FIELD CHANGE ORDER	NUMBER: RZ57-F001
--------------------	-------------------

APPLICABILITY: This FCO applies to RZ57-E Rev. "C01" and below on VS4000 Model 60, VS4000 VLC and VS4000 Model 90.

FCO RZ57-F001

INSTALLATION AND TEST PROCEDURE FOR FCO RZ57-F001

>>> FIGURE 1 <<<

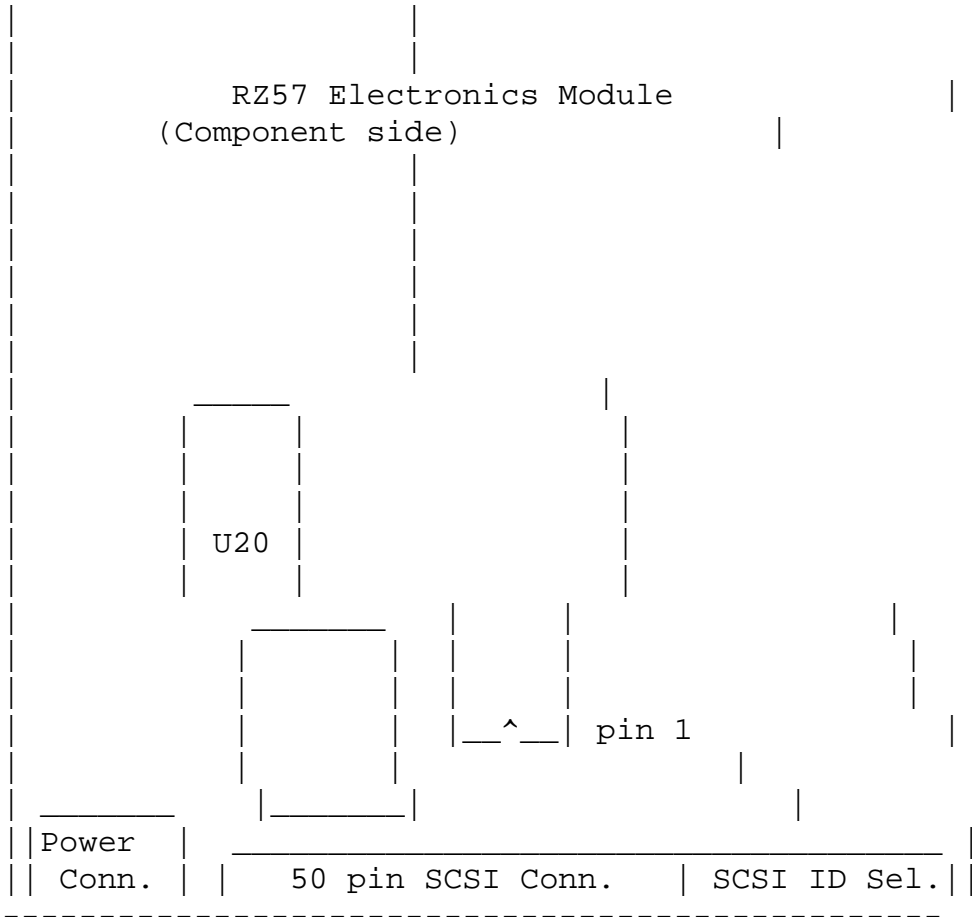
9. Remove the EPROM located at U20 located directly behind SCSI connector (See Figure 1). To remove U20, insert a small screwdriver under the chip and pry gently up, first on one end and then on the other end of the chip. Be very careful to avoid excessive force, as this may damage the electronics PCB and other components

NOTE: Be very CAREFUL that all chip pins are straight and properly positioned in the PCB socket when inserting the new EPROM chip at U20. This is important to avoid bending or otherwise damaging pins on the replacement EPROM.

10. Install the EPROM from FCO Kit EQ-01695-01

NOTE: Be sure that the EPROM chip is orientated correctly in the socket. Observe and note the position of the notch and/or Pin 1 marker on the chips, and be sure to insert the new chip with the same orientation as the old.
